XRAY

#375002 XRAY SOLID AXLE 1/10 PAN CAR-SET

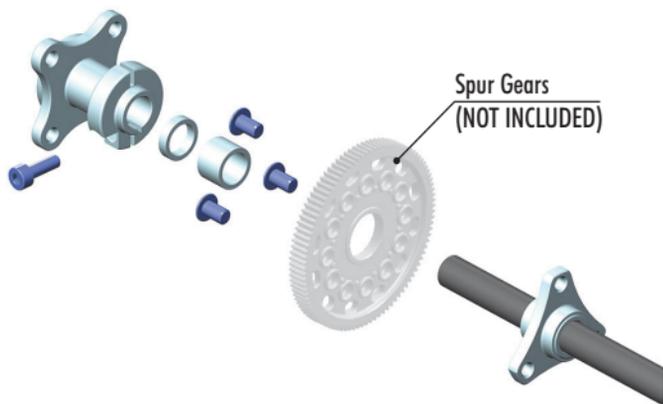
For the new X10'22, the shim thickness must be changed. Currently, for a ball diff, a 1mm shim is placed on one side and a 6mm shim on the other side. For a solid axle, you must take the 1mm shim off and use the shims you have in the bag for the solid axle. The 6mm shim stays on the other side. This will result in the same rear axle width from the center of the car.
